DA ACCESSIBILITY REPORT

PROJECT NAME **ECO TOURISM DEVELOPMENT**

PROJECT ADDRESS **951 BROKEN HEAD ROAD
BROKEN HEAD NSW 2481**

DATE: 16TH FEBRUARY 2021

| DRAWING | Accessibility Plan | | | DRAWN BY | CHKD BY | DATE | 17/9/20 |

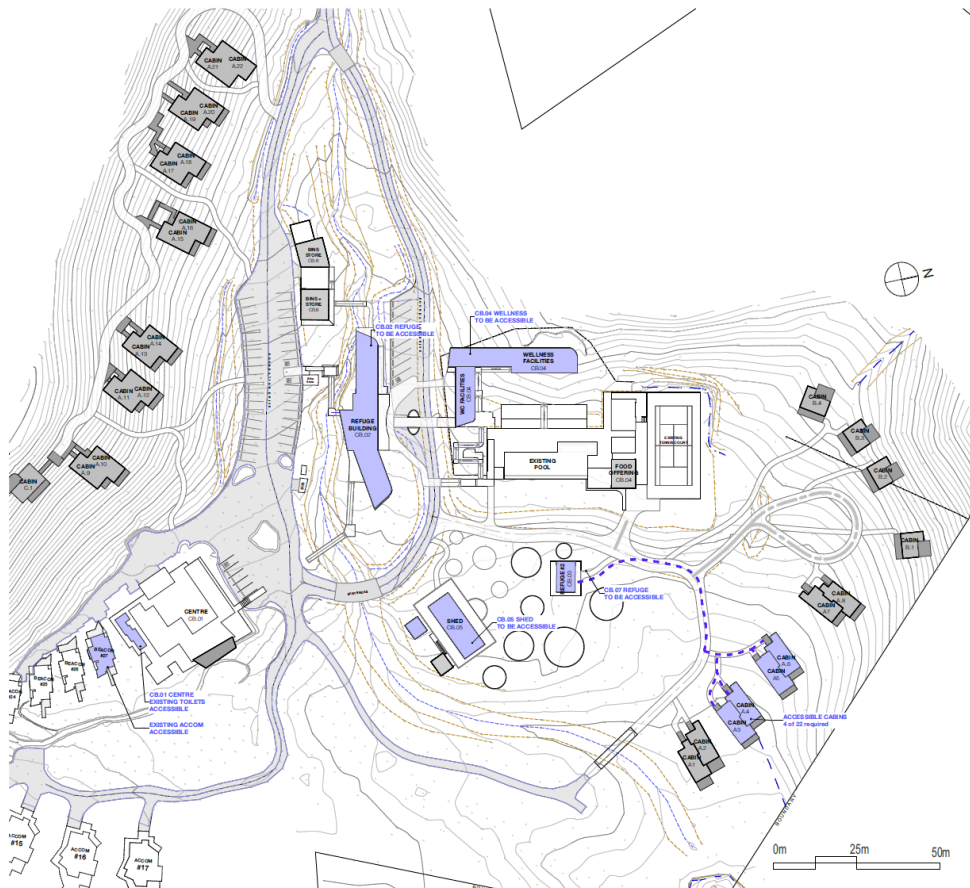
- 4 x Type A Cabins

- Distances to car parks to be minimum requirement for Class 3 Buildings.
- All Accessible Cabins to have accessible car spaces as per BCA requirements.
- Detail to be provided with Construction Certificate Drawings
- Performance solution required for Pedestrian Access
